# Carlisle-Virginia Rezone

23-0030Z

# Proposed Site Plan (Informational)

**SITE PLAN**

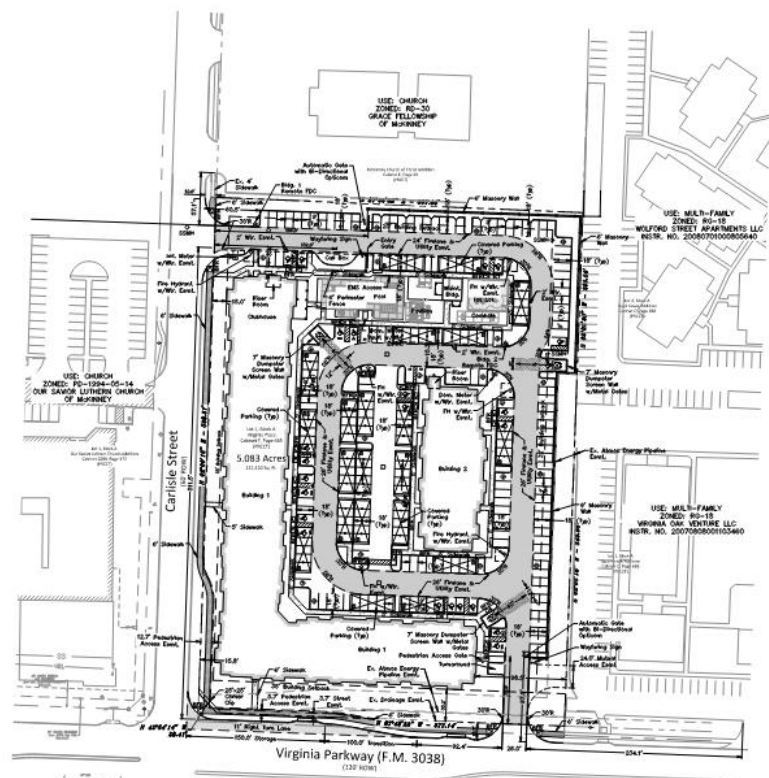
**REVIEWER GENERAL COMMENTS:**

Shall be protected by setbacks.

Shall be located a minimum 3 ft. clear from the base to any landscaping and provided a clear pathway to the fire lane and adjacent fire hydrant. Parking screening and landscaping are considered obstructions.

Shall be located no more than 100' from the center of the fire hydrant, on the near side. Shall be located 2'-6" from back of curb.

Shall be located near the corner of a building on the outside edge of the fire lane.
